IOWA DEPARTMENT OF NATURAL RESOURCES LAND & WATERS BUREAU WALLACE STATE OFFICE BUILDING

YELLOW RIVER STATE FOREST ROAD MAINTENANCE ALLAMAKEE COUNTY, IOWA PROJECT NUMBER: 22-03-03-01

March 15, 2024

This Addendum is issued to modify, explain or correct the original Drawings and Specifications, and is hereby made a part of the Contract Documents. Please attach this Addendum to the Project Manual in your possession. Insert the number and issue date of this Addendum in the blank space provided on the Proposal Form.

C.01

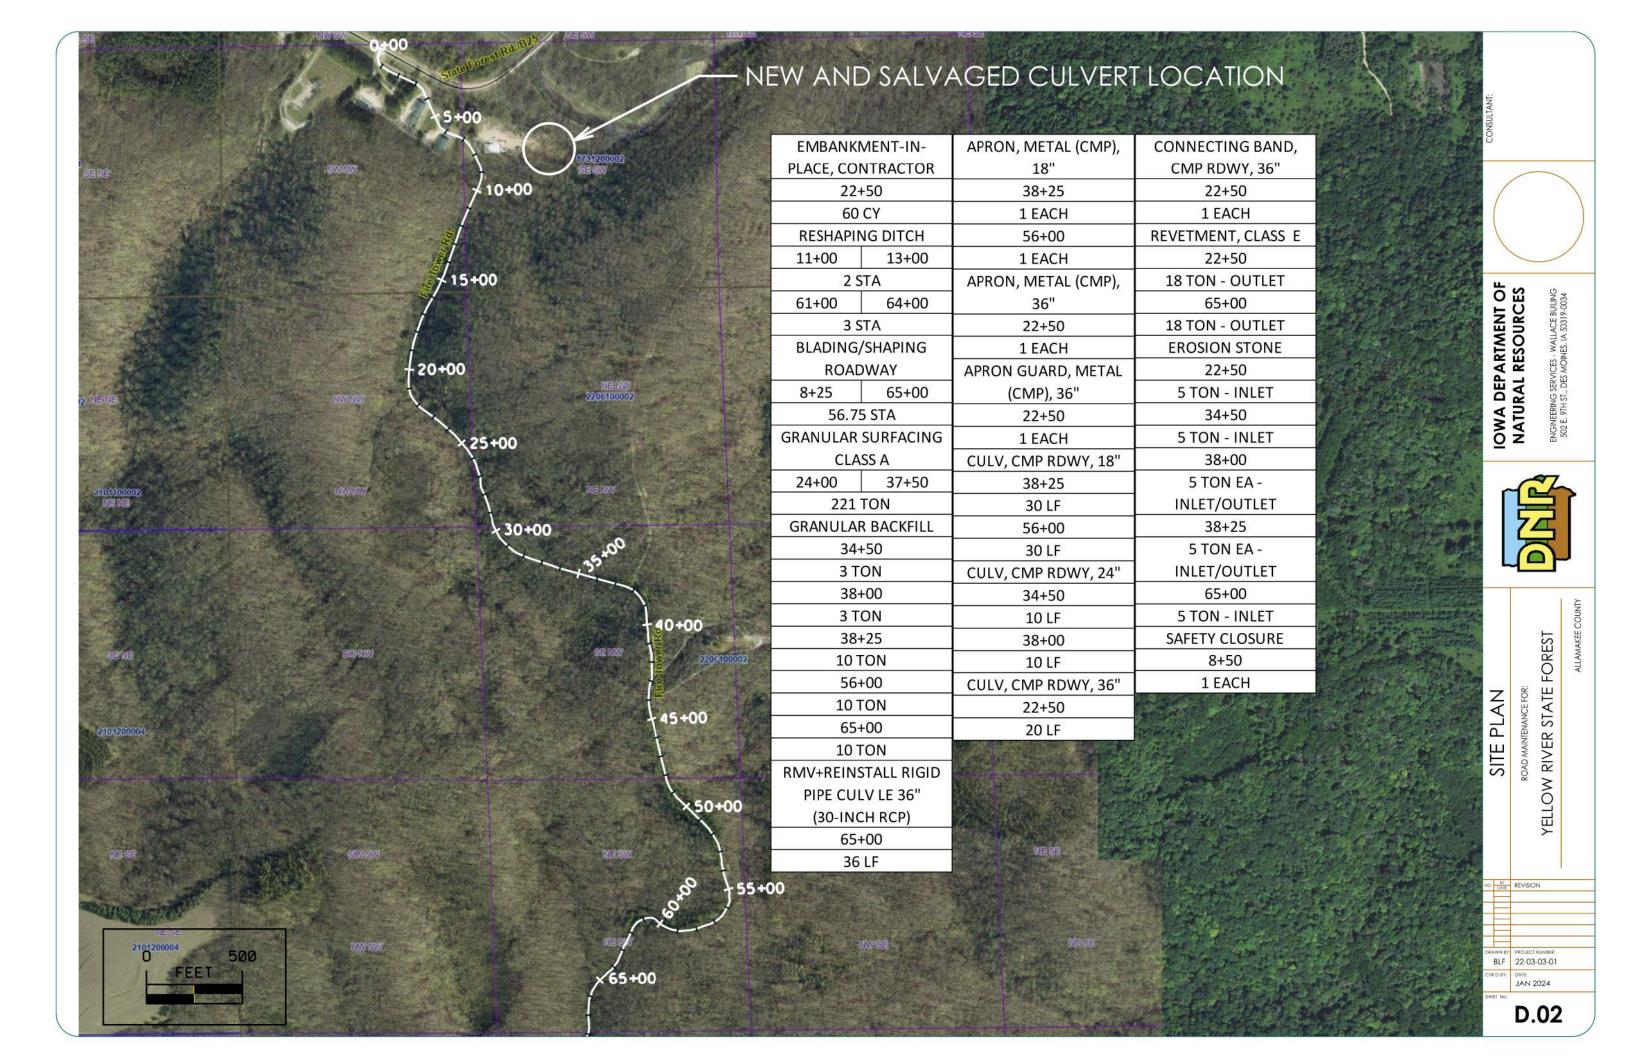
A. Sheet C.01 in the ESTIMATED PROJECT QUANTITIES SECTION.

CHANGE:

ITEM 6; 2402 - GRANULAR BACKFILL, from 50 TON to 56 TON.

ITEM 7; RMV+REINSTALL RIGID PIPE CULV LE 36" (36-INCH RCP) to RMV+REINSTALL RIGID PIPE CULV LE 36" (30-INCH RCP).

ITEM 8; 2417 - APRON, METAL (CMP), 18" from 2 EACH to 3 EACH.

ITEM 13; 2417 - CULV, CMP RDWY, 18" (30-FOOT LENGTHS) from 60 LF to 30 LF.

ITEM 14; 2417 - CULV, CMP RDWY, 24" from 10 LF to 20 LF.

ITEM 17; 2417 - CONNECTING BAND, CMP RDWY, 24" from 1 EACH to 2 EACH.

DELETE:

ITEM 9; 2417 - APRON, METAL (CMP), 24", 1 EACH.

ITEM 16; CONNECTING BAND, CMP RDWY, 18", 2 EACH.

ITEM 18; 2417 - CONNECTING BAND, CMP RDWY, 30", 1 EACH.

B. Sheet C.01 in the ESTIMATED REFERENCE INFORMATION (CONTINUED) SECTION.

ADD:

- A 1. 25+25 = 43°9.9740'N, 91°14.7610'W
 - 2. Existing 36-inch CMP with seep collar.
 - 3. Dig up, add 20-foot section+band, FES and grate on inlet.
 - 4. Reinstall culvert (including seep collar) on new alignment and elevations set by DNR Field Engineer.
 - 5. Cover with contractor furnish embankment.
 - 6. Salvage/move as much riprap as possible before placing.
 - 7. Place new riprap and erosion stone as directed by DNR Field Engineer.
- B 1. 34+50 = 43°9.8390'N, 91°14.7320'W
 - 2. Existing 24-inch CMP.
 - 3. Add 10-feet+band.
 - 4. Cover and place erosion stone as directed by DNR Field Engineer.
- C 1. 38+00 = 43°9.7990'N, 91°14.6470'W
 - 2. Existing 24-inch CMP.

- 3. Add 10-feet+band.
- 4. Cover and place erosion stone as directed by DNR Field Engineer.
- D 1. 38+25 = 43°9.7740'N, 91°14.5700'W
 - 2. Remove existing culvert and replace with 18-inch CMP.

- 3. Install new culvert on new alignment and elevations set by DNR Field Engineer.
 - 4. Place erosion stone as directed by the DNR Field Engineer.
 - 5. Salvage existing culvert and deliver to location indicated on plans.

- 6. Culvert is onsite.
- E 1. 56+00 = 43°9.4860'N, 91°14.5840'W
 - 2. Remove existing culvert and replace with 18-inch CMP.
 - 3. Install new culvert on new alignment and elevations set by DNR Field Engineer.

- 4. Place erosion stone as directed by the DNR Field Engineer.
 - 5. Salvage existing culvert and deliver to location indicated on plans.
 - 6. Culvert is onsite.

- F 1. 61+00 = 43°9.4860'N, 91°14.55840'W
 - 2. Move ditch away from roadway embankment pull existing material up against roadway embankment.
 - 3. DNR Field Engineer will mark limits.

- G 1. 65+00 = 43°9.4460'N, 91°14.6240'W
 - 2. Existing 30-inch RCP with connection failures.
 - 3. Remove and re-lay on new alignment and elevations set by DNR Field Engineer.

- 4. Wrap and pin ALL joints with type 3 connections. See B sheets for details
 - 5. Place new riprap and erosion stone as directed by DNR Field Engineer.

- H 1. 84+00 = 43°9.2380'N, 91°14.2040'W
 - 2. Place erosion stone along the existing embankment as directed by the DNR Field Engineer.
 - 3. Limits of placement will be set by the DNR Field Engineer.

- 4. Move existing root ball out of ditch/channel.
- 1. 117+25 = 43°8.8590'N, 91°14.2040'W
 - 2. Remove existing culvert and replace with 18-inch CMP.
 - 3. Install new culvert on new alignment and elevations set by DNR Field Engineer.

- 4. Place erosion stone as directed by the DNR Field Engineer.
 - 5. Salvage existing culvert and deliver to location indicated on plans.
- J 1. 121+75 = 43°8.7870'N, 91°14.1720'W

- 2. Remove existing culvert and replace with 30-inch CMP with FES.
 - 3. Install new culvert on new alignment and elevations set by DNR Field Engineer.

- 4. Place new riprap and erosion stone as directed by DNR Field Engineer.
 - 5. Salvage existing culvert and deliver to location indicated on plans.
 - 6. Culvert is onsite.
